THE VILLAS AT CLAREMONT RANCH

STREET IMPROVEMENTS PLANS

THE VILLAS AT CLAREMONT RANCH

STORM SEWER PLANS

Computer File Information, Sheet Revisions, Colorado Department of Transportation, CURB INLET TYPE R, STANDARD PLAN NO. M-604-12, Standard Sheet No. 1 of 2.

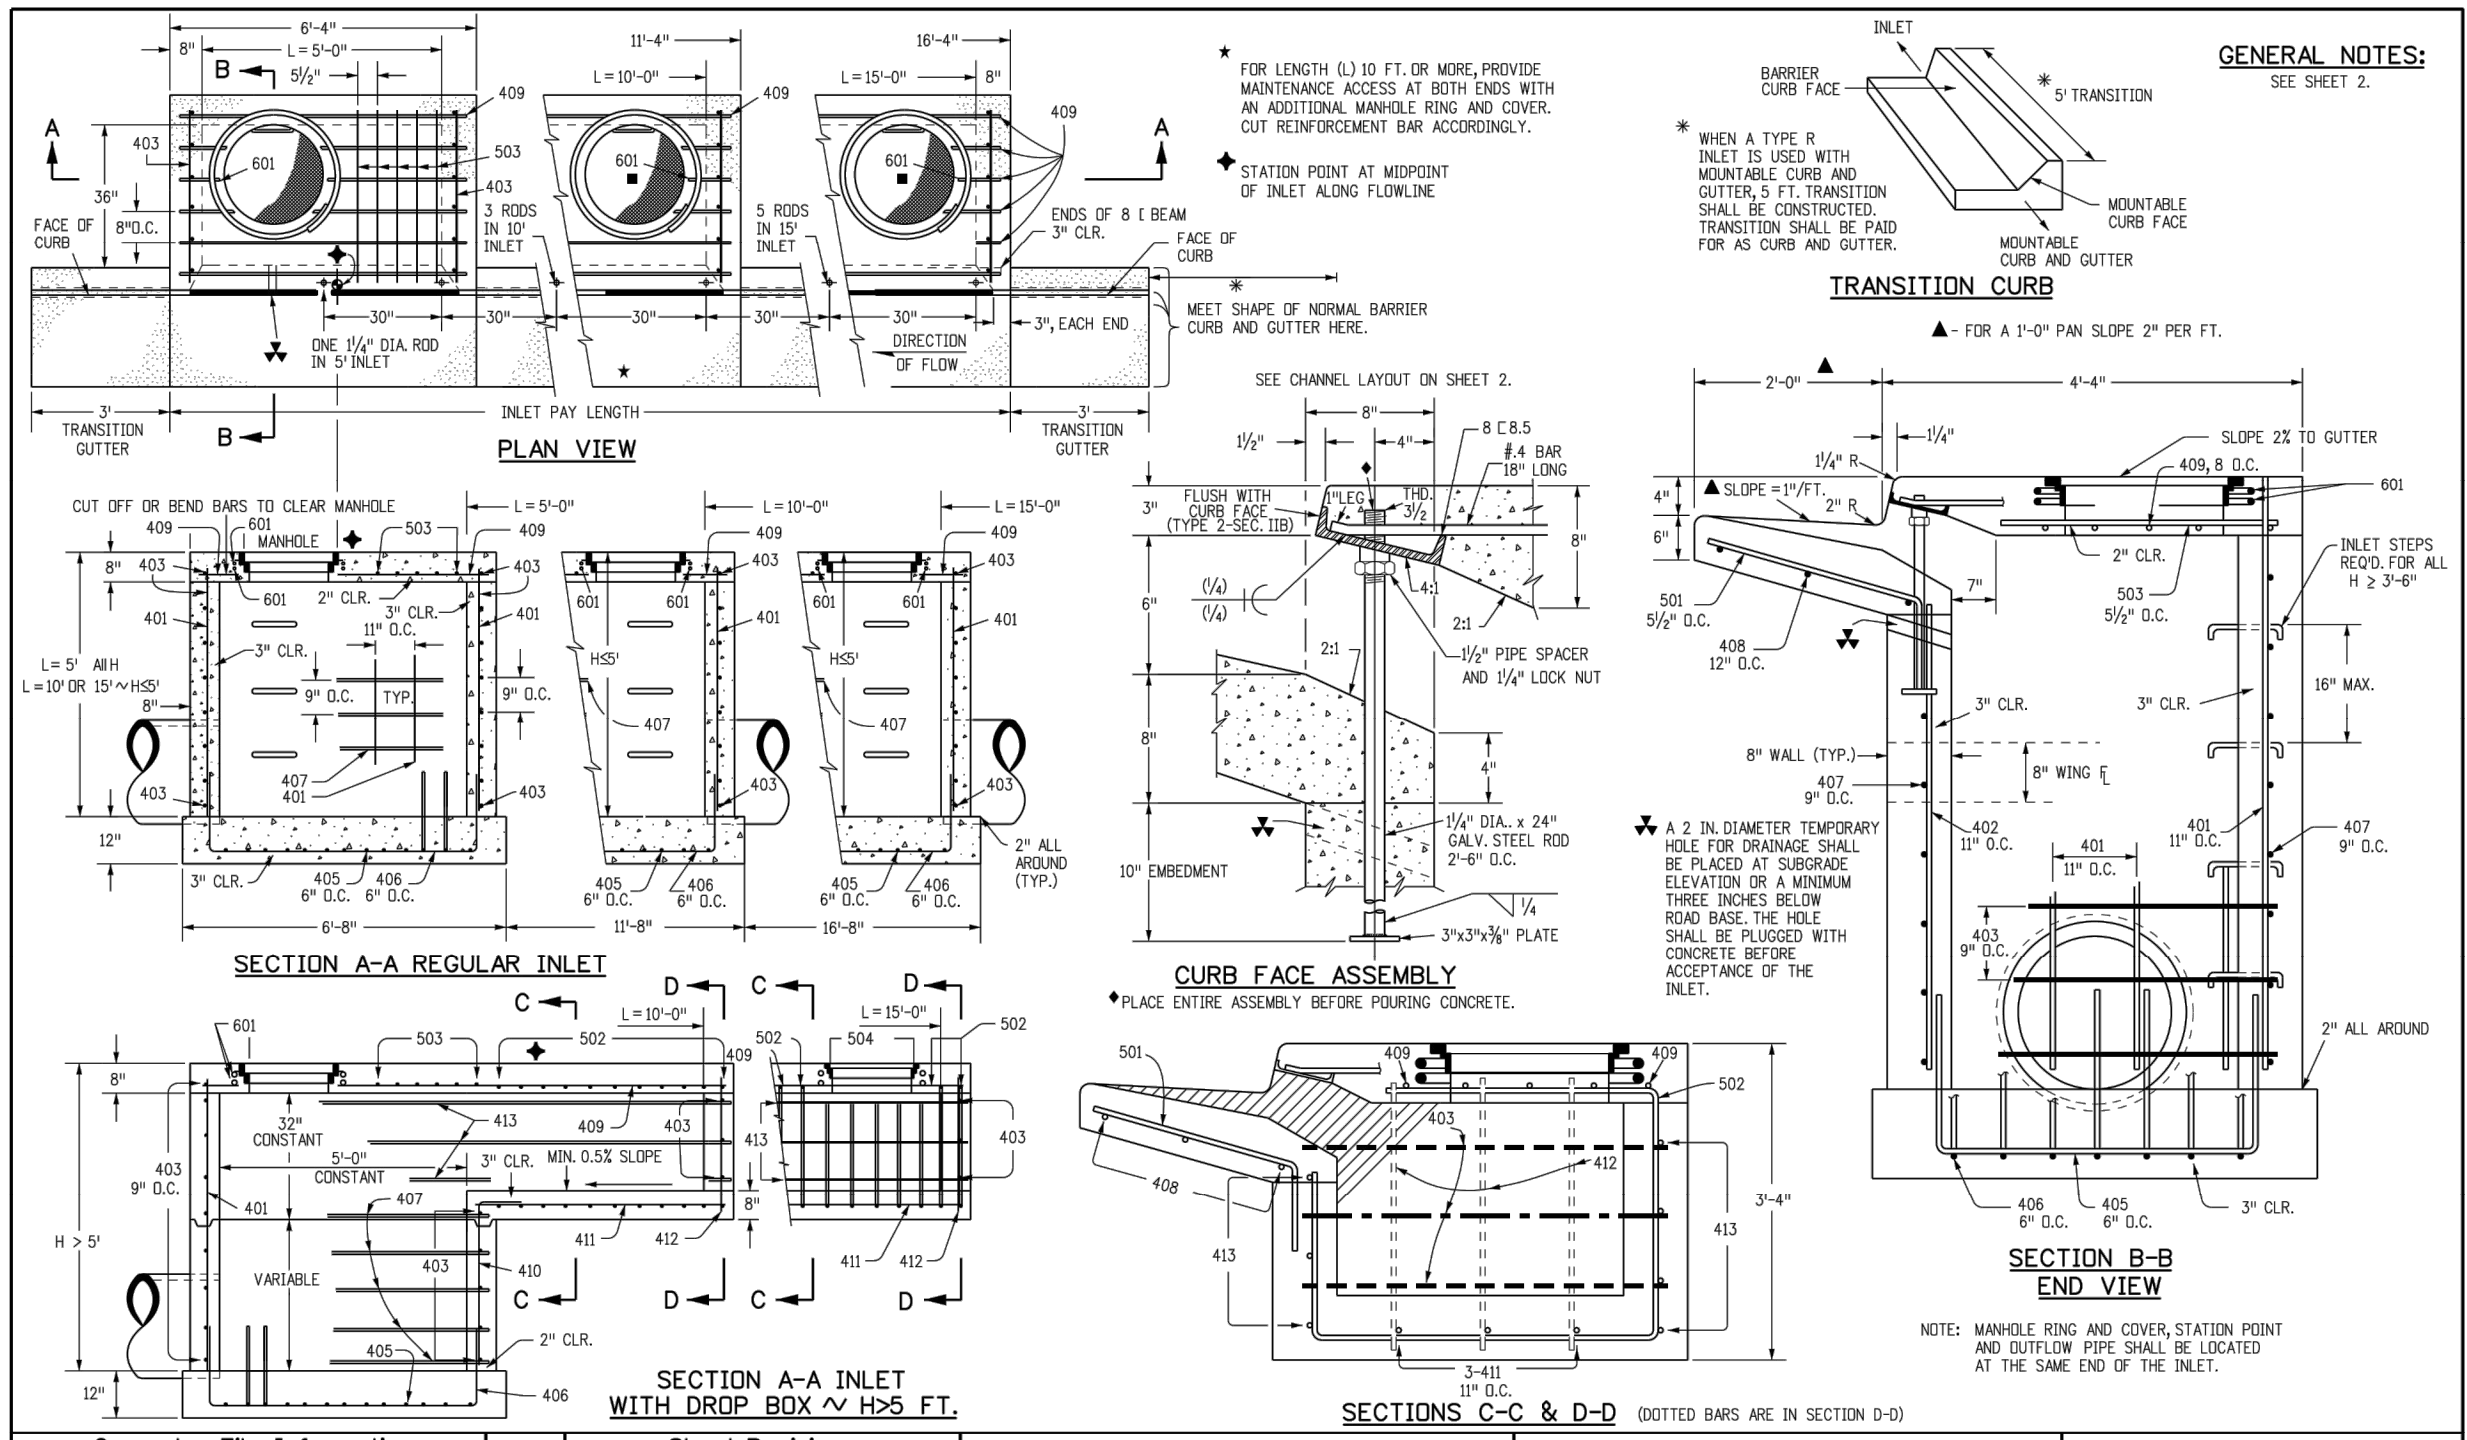
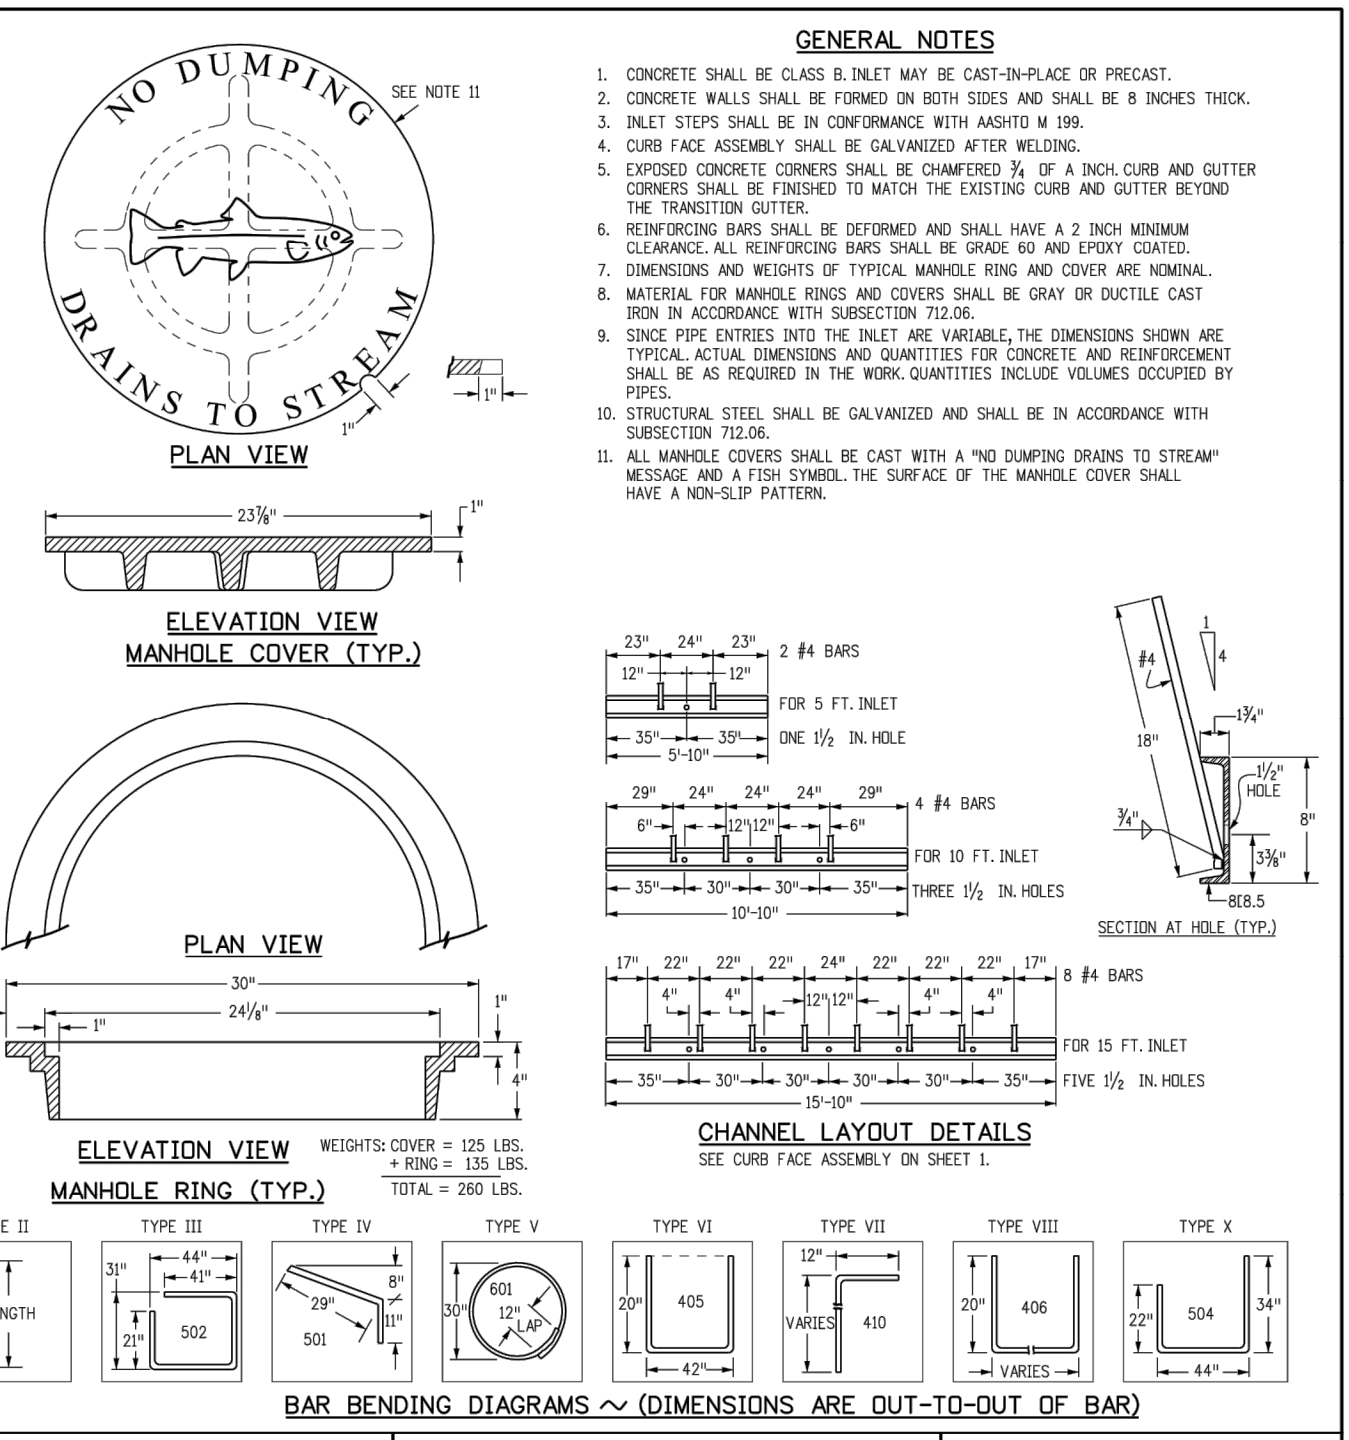
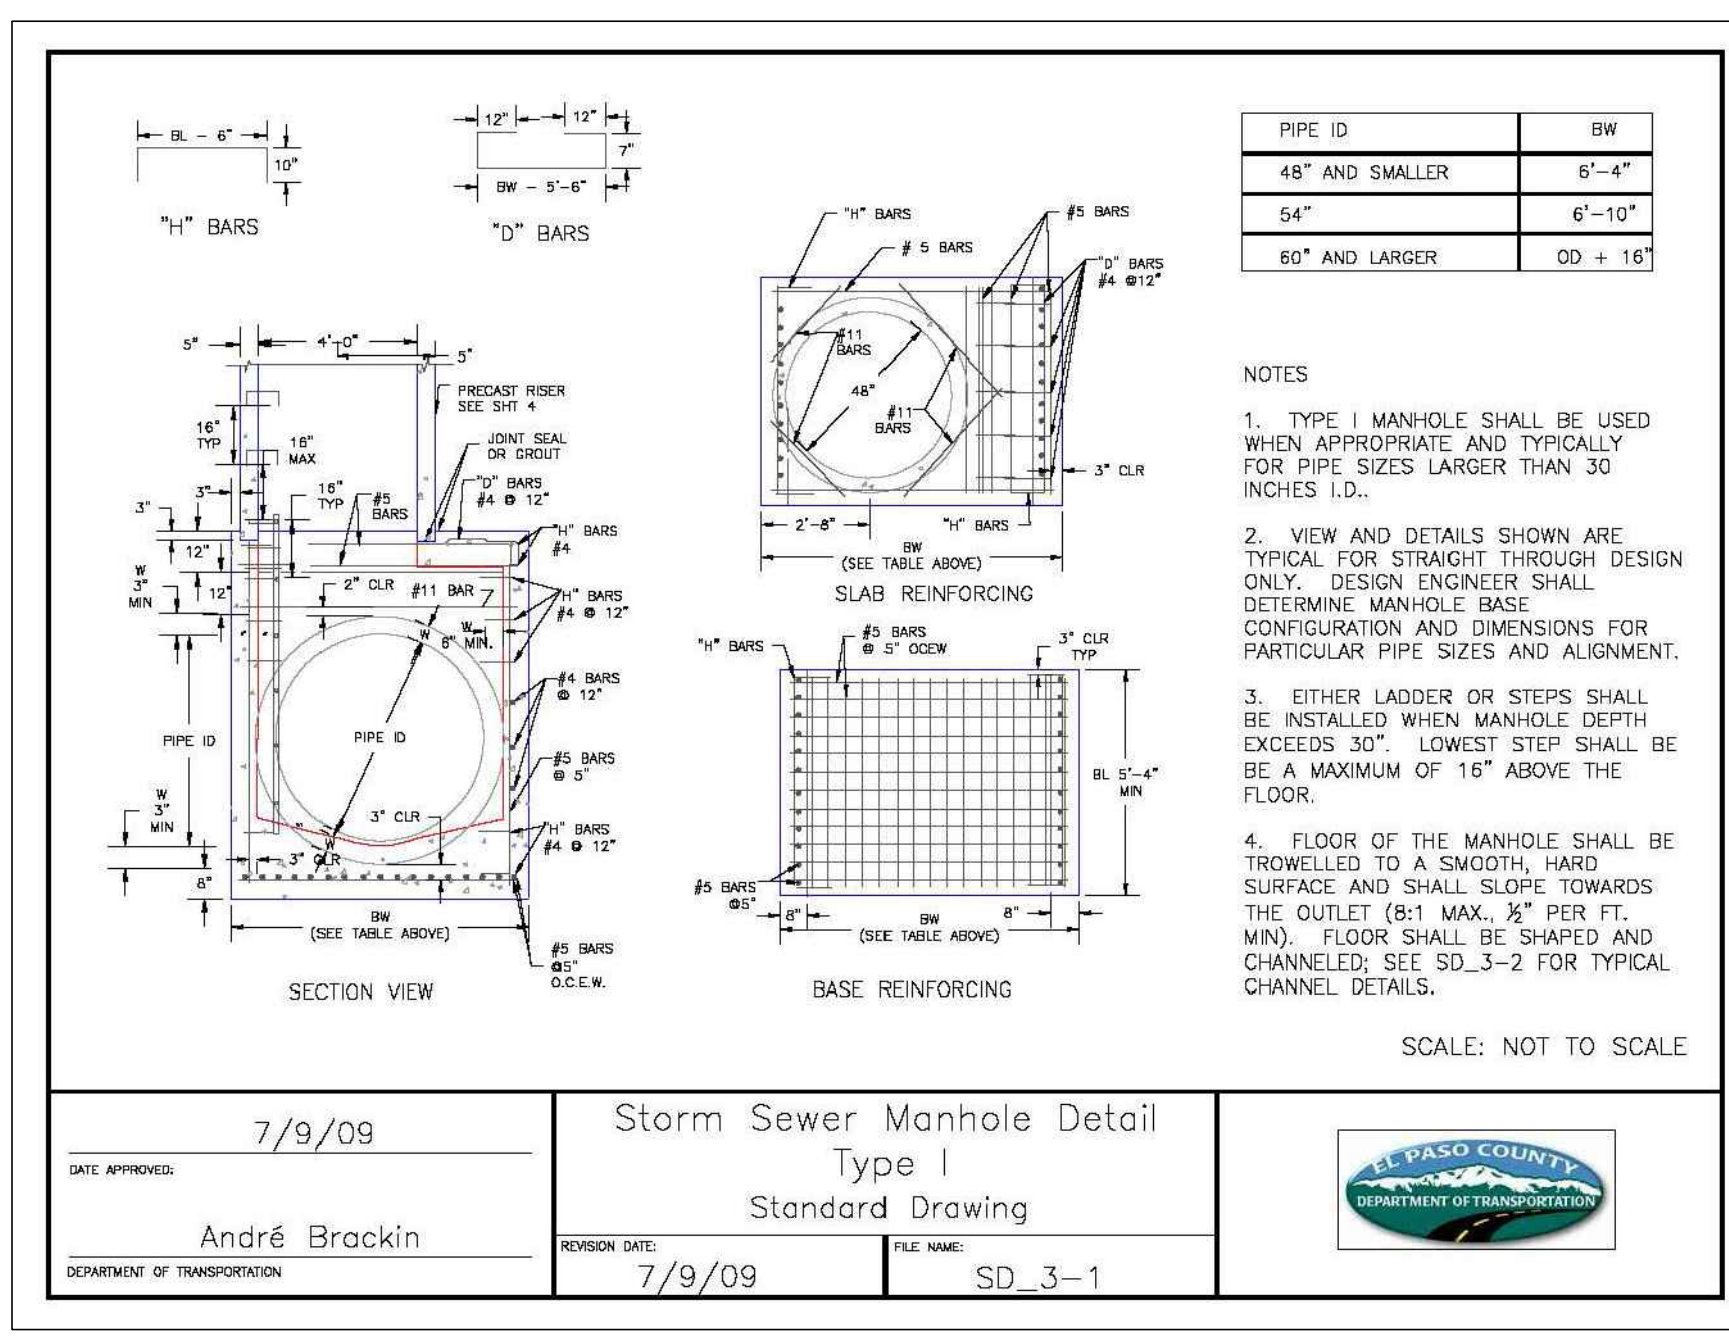
Provide detail for riprap outlet protection

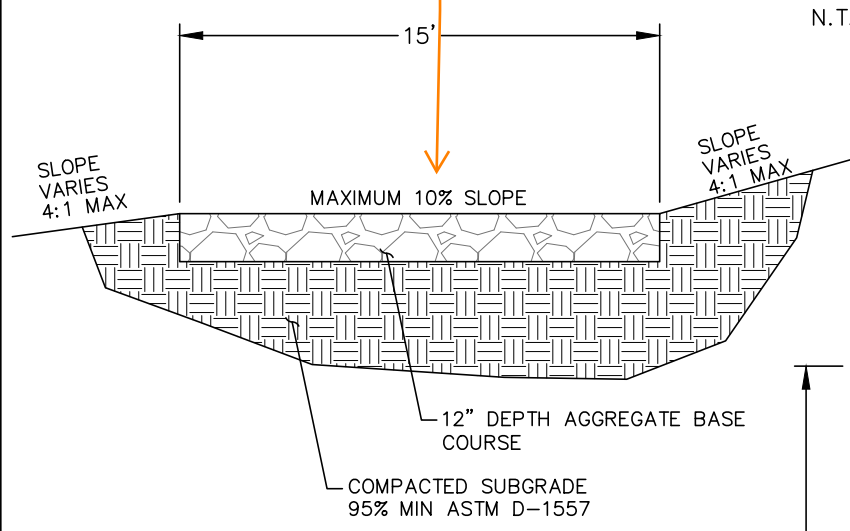
clarify that this is for longitudinal slope so it's not confused with the max cross slope which is 2%.
